Comments on the “Stormwater Analysis and Calculations Report” and Site Design Plans, Prepared by Meridian Associates for the Proposed Solar Installation in the Scarborough Brook Watershed by BWC Scarborough Brook, LLC

**Prepared by Stephen P. Garabedian, Ph.D.,
For the Belchertown Planning Board**

February 26, 2019

Figure 1. Regression of total runoff from the BWC-Gulf Road project for the 2-year, 10-year, and 100-year storms versus the peak stormwater flow rates for the same storms for the proposed conditions; data from the 1/18/2019 Meridian Stormwater Calculations and Analysis Report.

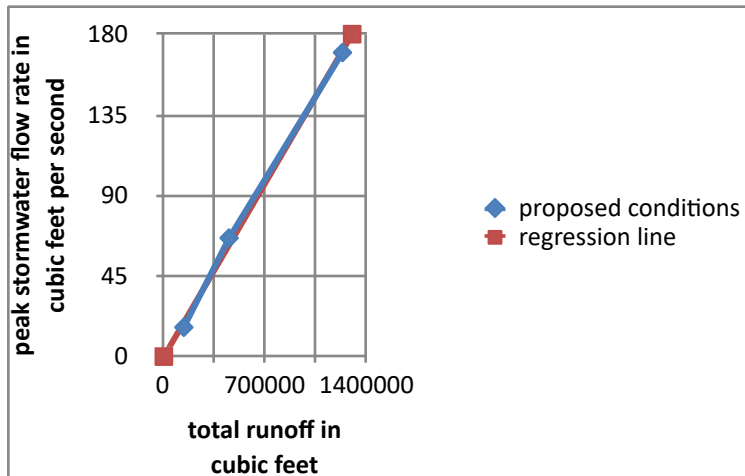
With the above estimate of total infiltration (41,336 ft³), it is possible to predict the peak stormwater flow rate using a regression analysis for the proposed conditions (post) peak stormwater flow rates. The graph below (fig. 1) shows the three peak flow rates plotted with the associated volumes of runoff (component C in table 1) for the 2-year, 10-year, and 100-year storms as predicted by Meridian Associates. A linear regression through these data points produces a regression coefficient of 0.999, indicating that there is a very good correlation between the total stormwater runoff and the peak stormwater flow rates as predicted by the model used by Meridian.

The total stormwater runoff from the project area can then be calculated by subtracting the infiltration volume predicted using the mounding analysis from the total runoff from all the subcatchment areas for the 10-year storm (628,724 – 41,336 = 587,388 cubic feet). The updated peak stormwater flow rate for the larger total runoff can then be predicted using the regression relation; this value is 80.7 cubic feet per second (ft³/s), 22% greater than the original prediction by Meridian Associates. The updated peak stormwater flow rate under the proposed conditions is larger than the predicted peak flow rate of 77.8 ft³/s for the existing condition, indicating that, in fact, the peak stormwater flow rate under the proposed conditions will exceed the existing peak stormwater flow rate for the 10-year storm, thus failing the Massachusetts Stormwater Standard that requires the proposed condition not exceed the existing condition for the 10-year storm.
